ATR on Quality Control Check Report. (Apartments)

Flat No	H-506	QC report stage	—	SL No	42907
Company	MDWP	Project	MDWP	Phase	—
Prepared by	P. S. H. A. K. A.	Sign	<i>[Signature]</i>	Date	09/05/24
Project Manager	S. S. S. S. S.	Sign	<i>[Signature]</i>	Date	09/05/24
Receipt by QC date		Sign		Other	
Receipt at HO date		Sign		Other	
Checked By MD on		MD Sign		For filling	☐ Yes ☐ No

GULMOHAR RESIDENCY

Details of Additions & Alterations

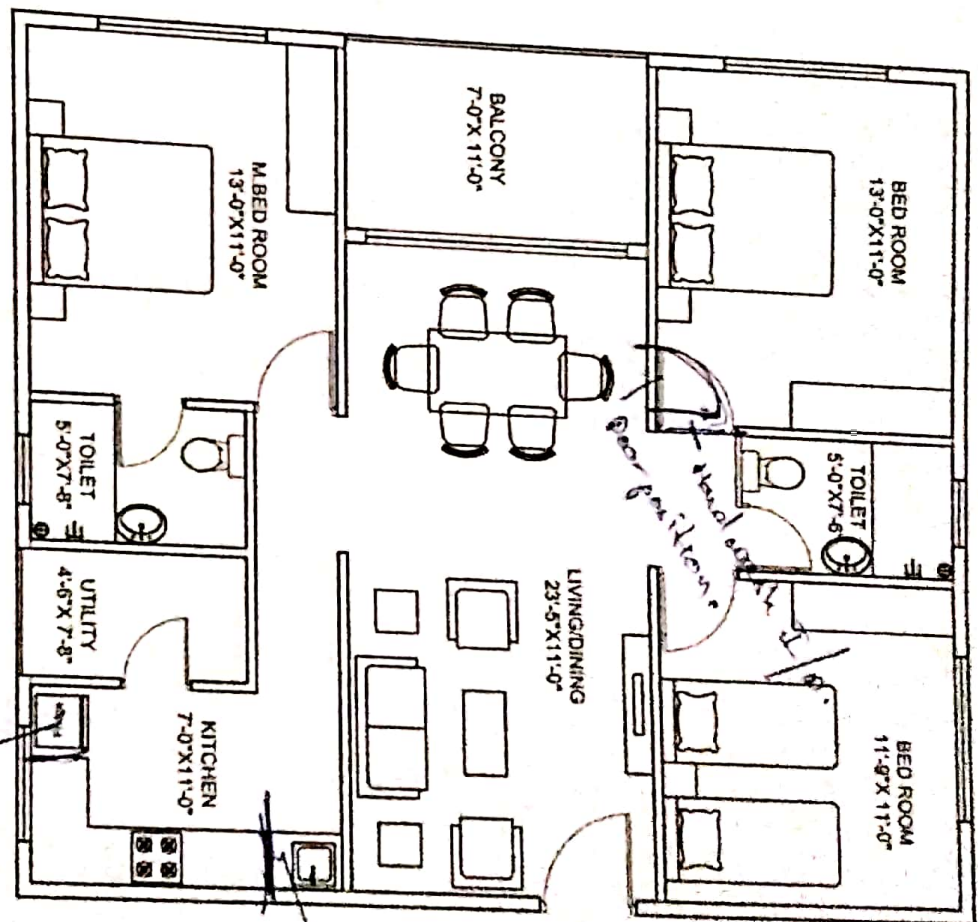
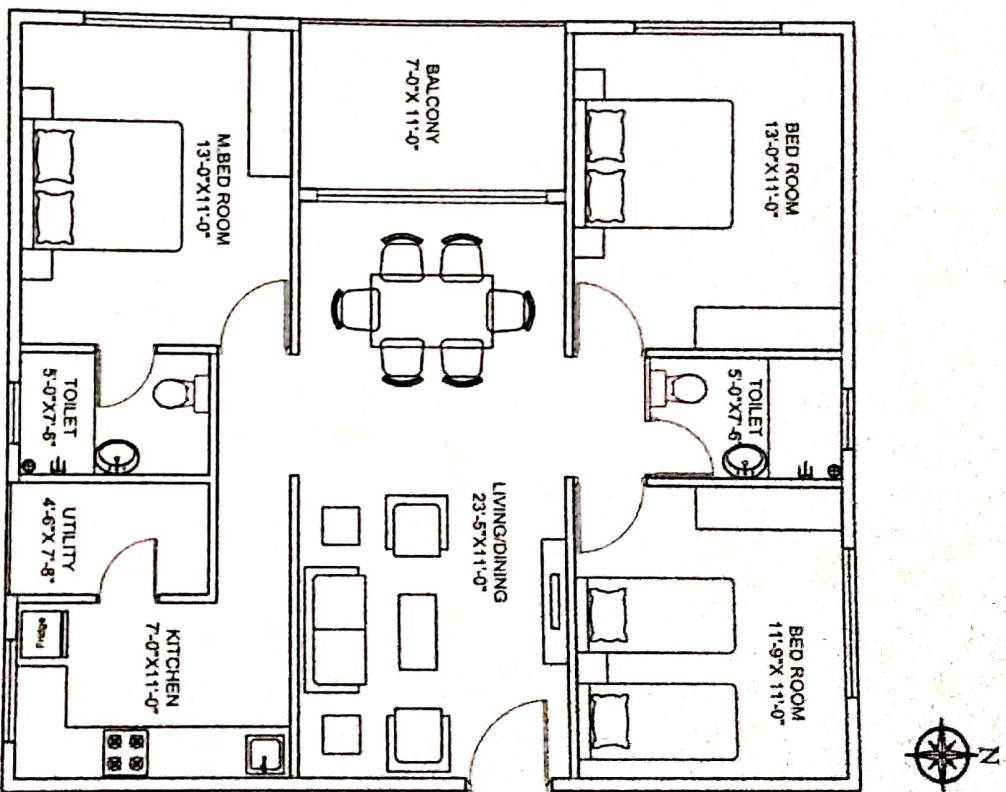
21' 5" to be removed
